Product Change Notification

Date Issued :	April 05, 2023	PCN Number :	513032
Reason for Change :	Change to Product		
Description of Change :	The change is at the customer request due to a problem that coupling nut is falling out from the shell. - Spring ring 1203180090 dimension change to 0.9x0.9 - shell 1203180450 added dimension 45 for edge - nut 1203180089 changed tolerance for dim 1 to -0.2		
Reason for Short Notice :	Corrective Actions		
Assessment of Change :	First Article Inspection		
Planned Implementation Date :	August 25, 2023		
Sample Availability Date:	July 19, 2023		
Internal Molex Qualification Date :	July 19, 2023		
Last date to request Samples by Customer :	July 24, 2023		
Traceability Code Markings / Date :	No special marking on the product or packaging

Before Picture

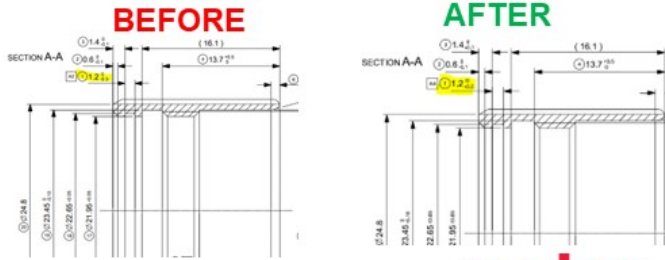
- Changing dimensions of spring ring

- Adding dimension for edge

- Changing tolerance

- The change is at the customer request due to a problem that coupling nut is falling out from the shell.
 - Spring ring 1203180090, dimension change to 0.9x0.9
 - shell 1203180450, added dimension 45 for edge
 - nut 1203180089, changed tolerance for dim 1 to -0.2
